Your ref
APP/20/00298

Our ref
PLAN-033656

Proposal: Erection of 1No. 2 bed end of terraced dwelling with associated parking and access.
Site: APP/20/00298: - 43 Blendworth Crescent, Havant, PO9 2BD.

Southern Water MapGuide Browser

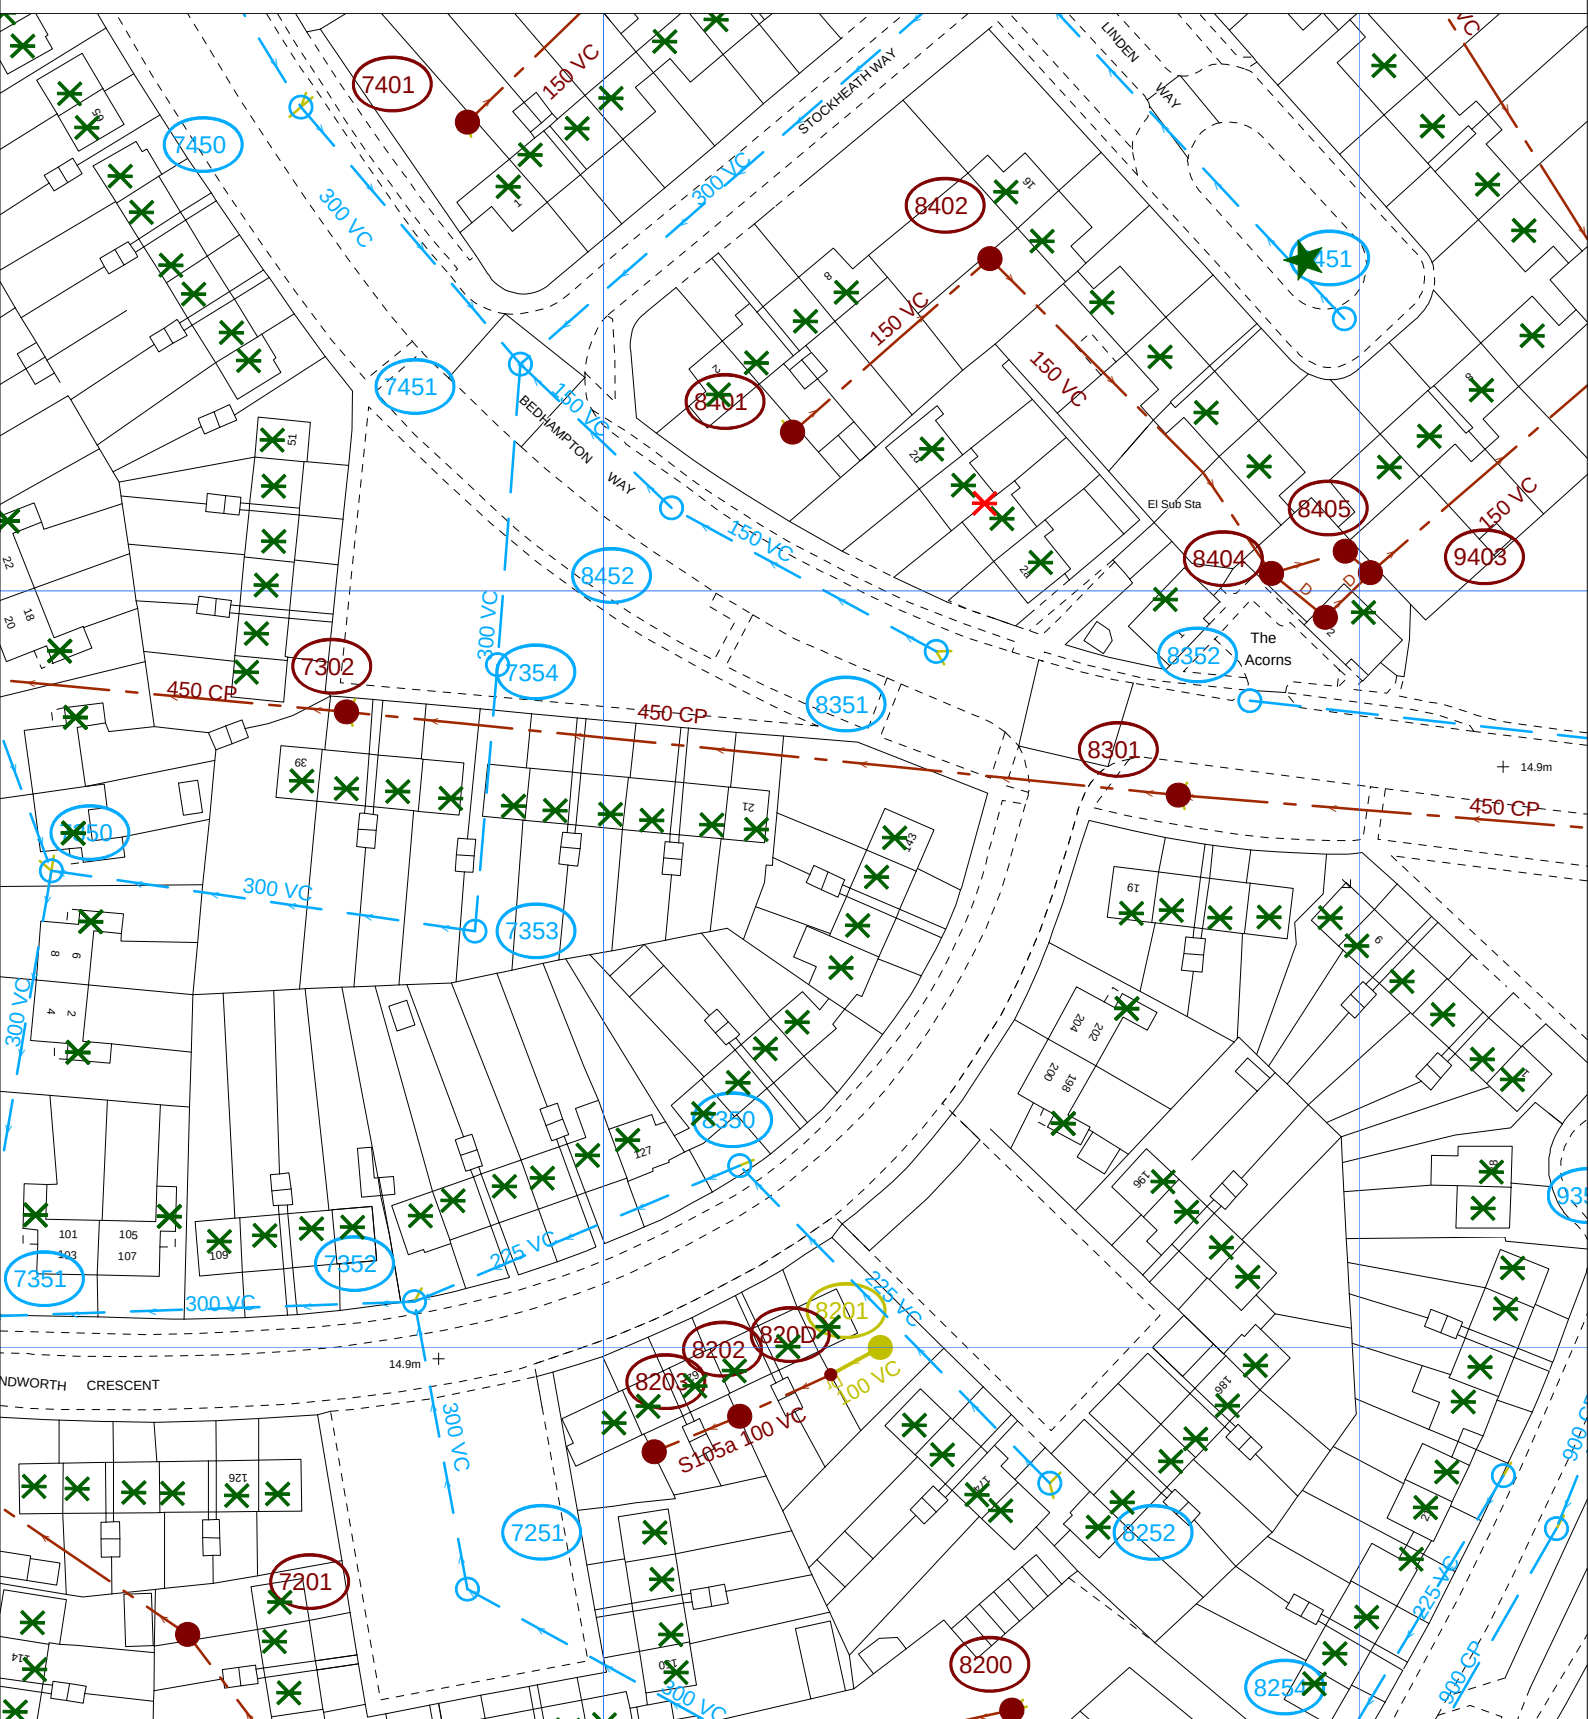
The attached plan shows that the proposed development will lie over an existing public foul sewer which will not be acceptable to Southern Water. The exact position of the public sewer must be determined on site by the applicant before the layout of the proposed development is finalised.

- The public foul sewer requires a clearance of 3 metres on either side of the gravity sewer to protect it from construction works and to allow for future access for maintenance.
- No development or tree planting should be carried out within 3 metres of the external edge of the public gravity sewer without consent from Southern Water.
- No new soakaways should be located within 5 metres of a public sewer.
- All existing infrastructure should be protected during the course of construction works.

It might be possible to divert the sewer, so long as this would result in no unacceptable loss of hydraulic capacity, and the work was carried out at the developer's expense to the satisfaction of Southern Water under the relevant statutory provisions.

Alternatively, the applicant may wish to amend the site layout, or combine a diversion with amendment of the site layout. If the applicant would prefer to advance these options, items above also apply.

In order to protect drainage apparatus, Southern Water requests that if consent is granted, a condition is attached to the planning permission; for example, the developer must advise the local authority (in consultation with Southern Water) of the measures which will be undertaken to divert the public sewers, prior to the commencement of the development.
